**Development Consent Order application for Portishead Branch Line – MetroWest Phase 1  
Application Reference: TR040011**

**Development Consent Order application for Portishead Branch Line – MetroWest Phase 1**  
**Application Reference: TR040011**  
**Response to DfT letter of 28<sup>th</sup> January 2022**

**Applicant: North Somerset District Council**  
**Development Consent Order application for Portishead Branch Line – MetroWest Phase 1**  
**Application Reference: TR040011**

Figure 5 - Vegetation risk assessment in old standard NR/L2/TRK/5201

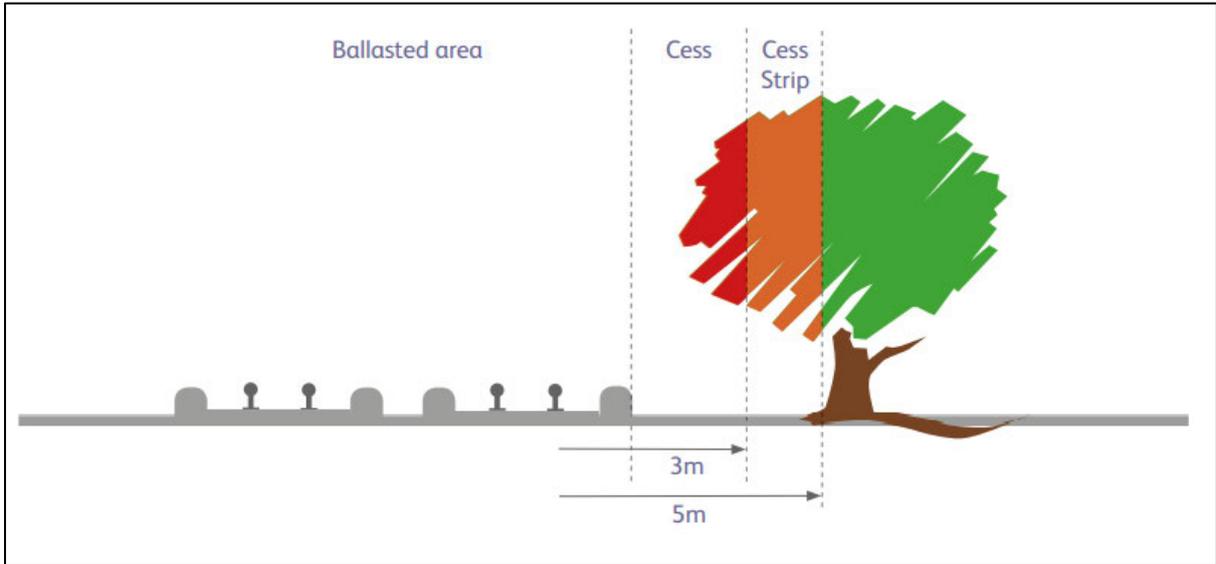
It should be noted that since the initial assessment was undertaken (Figure 1) an independent review was undertaken, called 'Valuing Nature – A Railway for People and Wildlife - The Network Rail Vegetation Management Review'. In its own words, the review sought to answer the question "can Network Rail, through the way it manages lineside vegetation, ensure the safety and performance of the railway while improving the natural capital that it owns on behalf of the nation". This review makes good reference to the environmental and safety legislation that Network Rail must follow, which is shown in the extract in Figure 4

It was this review that prompted the standards change stated above, which changed the way the vegetation risk was assessed. The assessment in Table 8.4 of the Applicant’s Habitat Regulation Assessment (Figure 1 above) was undertaken while the older standards were in place, where any vegetation within 3m of the railway (with no vertical limit) would fall within the red zone (Figure 5). The new standards involve using 45 degree angle for establishing the ‘Immediate Action’ zone as shown within Figure 6.
